UNITED STATES PATENT AND TRADEMARK OFFICE

APPLICATION NO.	FILING DATE	FIRST NAMED INVENTOR	ATTORNEY DOCKET NO.	CONFIRMATION NO.
10/666,499	09/19/2003	Peter K. DeGabriele	087522-452-466	8961
28104	7590	10/07/2005		
JONES DAY 77 WEST WACKER CHICAGO, IL 60601-1692			EXAMINER GABLER, PHILIP FRANCIS	
			ART UNIT	PAPER NUMBER
			3637	
DATE MAILED: 10/07/2005

Office Action Summary	Application No. 10/666,499	Applicant(s) DEGABRIELE ET AL.	
	Examiner Philip Gabler	Art Unit 3637

DETAILED ACTION

Fig. 1

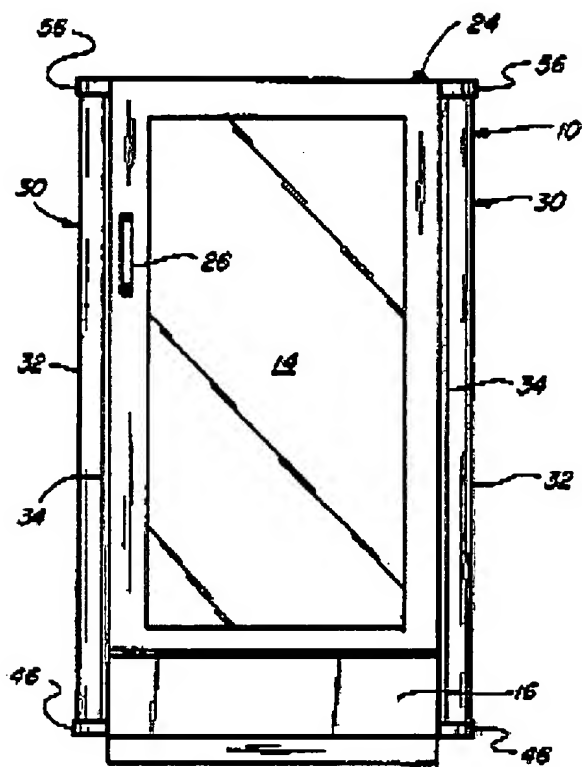
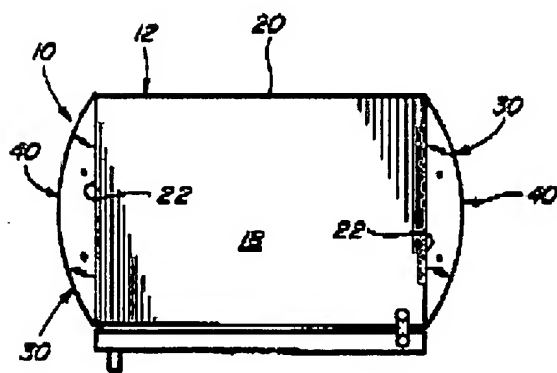
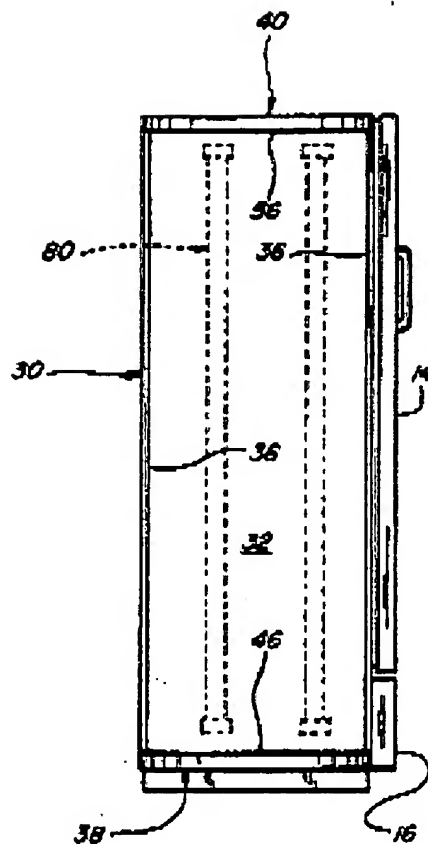
5. Claim 1 is rejected under 35 U.S.C. 102(b) as being anticipated by Trulaske (US Patent Number 5584547). Trulaske discloses a storage cabinet wherein: said cabinet includes first and second side walls (32), top and bottom walls (18) and (38), a vertically adjustable door (14), a door hinge (24) and a spacer panel (16); said side walls each includes a height, a length, a forward edge and a rear edge; said top and bottom walls each includes a length and a width; said top and bottom walls are attached to said side walls along a portion of the length of said side walls, the lengths of said top and bottom walls being less than the lengths of said side walls; said spacer panel is attachable to

said side walls adjacent to either said top wall or to said bottom wall as a function of which of said top wall and bottom wall is in the vertically lowest location; said door is attached to one of said side walls at a vertical position which location is function of the placement of said top and said bottom wall; and said door hinge is attached to said door and attachable to said one of said side walls.

Coonan '935 Figure 5

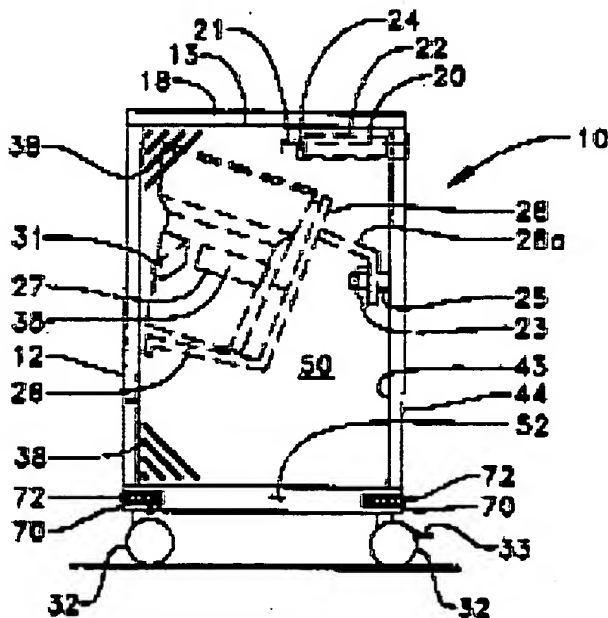
7. Claim 2 is rejected under 35 U.S.C. 103(a) as being unpatentable over Trulaske in view of Coonan (US Patent Number 5758935). Trulaske discloses a cabinet as recited in claim 1, but does not include a set of casters. Coonan discloses a computer workstation including a set of casters (32) attached to the bottom wall (52). It would have been obvious to one of ordinary skill in the art at the time the invention was made to modify Trulaske's cabinet to include a set of casters as taught by Coonan to facilitate movement of the cabinet.

Davidson '851 Figure 4

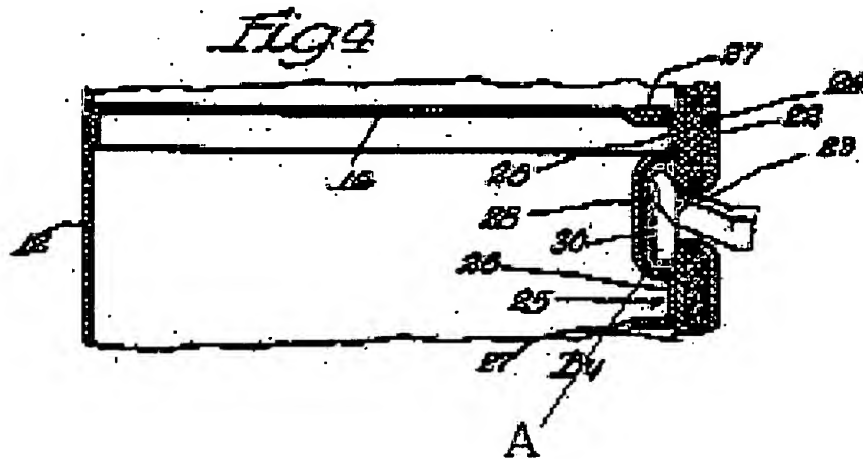
8. Claim 3 is rejected under 35 U.S.C. 103(a) as being unpatentable over Trulaske in view of Davidson (US Patent Number 2653851). Trulaske discloses a cabinet as recited in claim 1, but does not include a slanted edge on the forward edge of the side wall. Davidson discloses a cabinet with a slanted edge (A). It would have been obvious to one of ordinary skill in the art at the time the invention was made to modify Trulaske's cabinet to include a slanted edge on the forward edge of the side wall to facilitate the operation of a door as taught by Davidson.

Clegg '514 Figure 1

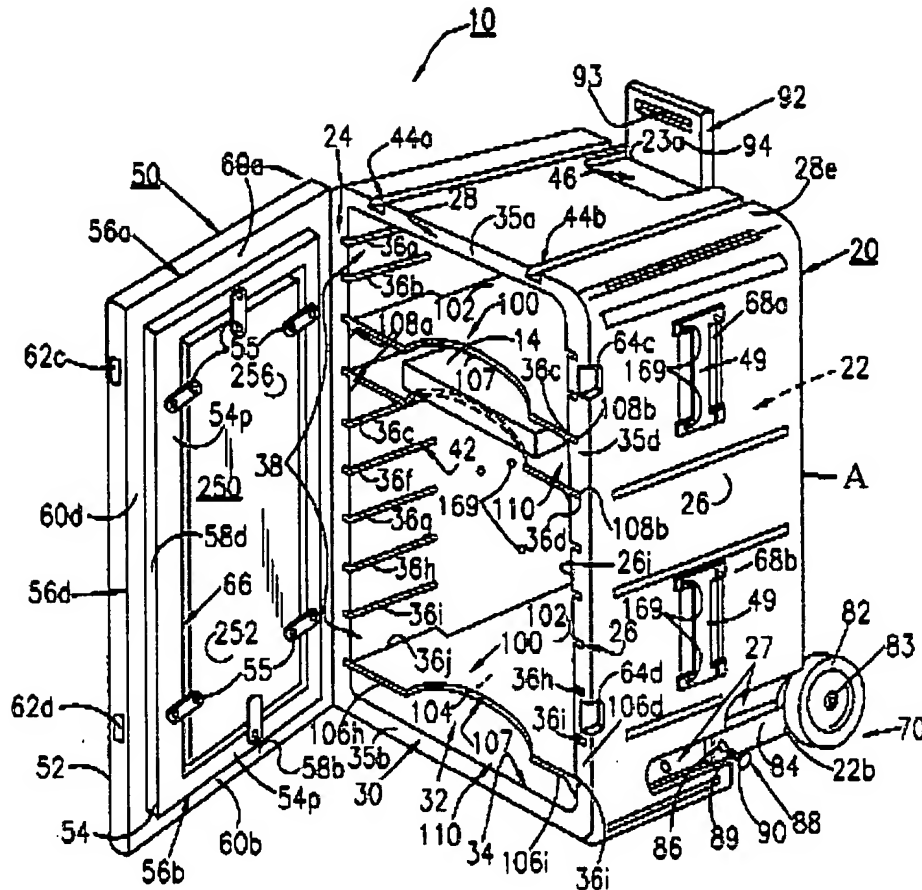
10. Claim 4 is rejected under 35 U.S.C. 103(a) as being unpatentable over Trulaske in view of Clegg (US Patent Number 6520514). Trulaske discloses a cabinet as recited in claim 1, but does not include a recess in the rear edge of the side wall not attached to the door. Clegg discloses a filing case (10) with a recess (27) formed in the rear edge (A) of its side wall (26) not attached to its door (50). It would have been obvious to one of ordinary skill in the art at the time the invention was made to modify Trulaske's cabinet to include a recess as taught by Clegg for wires, etc.

Clegg discloses a filing case (10) with a recess (27) formed in the rear edge (A) of its side wall (26) not attached to its door (50). It would have been obvious to one of ordinary skill in the art at the time the invention was made to modify Trulaske's cabinet, combined with the Coonan and Davidson modifications, to include a recess as taught by Clegg for wires, etc.

Gianelo '308 Figure 3

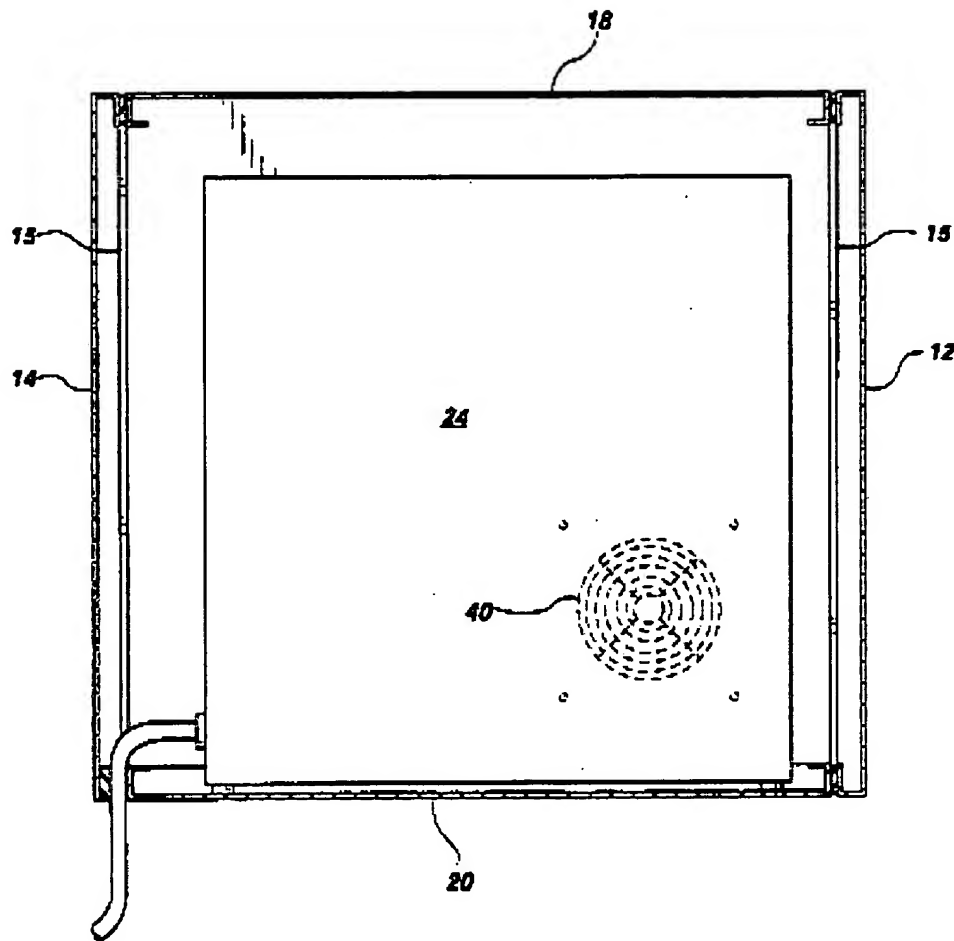
12. Claims 5 and 6 are rejected under 35 U.S.C. 103(a) as being unpatentable over Trulaske in view of Gianelo (US Patent Number 6589308). Trulaske discloses a cabinet as recited in claim 1, but does not include an air grille attached to the side wall or a back panel forming a rear opening. Gianelo discloses a computer cabinet including an air grille (40) attached to the side wall (24), and a back panel (12) forming a rear opening (15). It would have been obvious to one of ordinary skill in the art at the time the invention was made to modify Trulaske's cabinet to include an air grille and a rear opening as taught by Gianelo for ventilation of and access to the device stored in the cabinet.

attached to the side wall or a back panel forming a rear opening. Gianelo discloses a computer cabinet including an air grille (40) attached to the side wall (24), and a back panel (12) forming a rear opening (15). It would have been obvious to one of ordinary skill in the art at the time the invention was made to provide Trulaske's cabinet, as modified by Coonan, Davidson, and Clegg, to include an air grille and a rear opening as taught by Gianelo for ventilation of and access to the device stored in the cabinet.
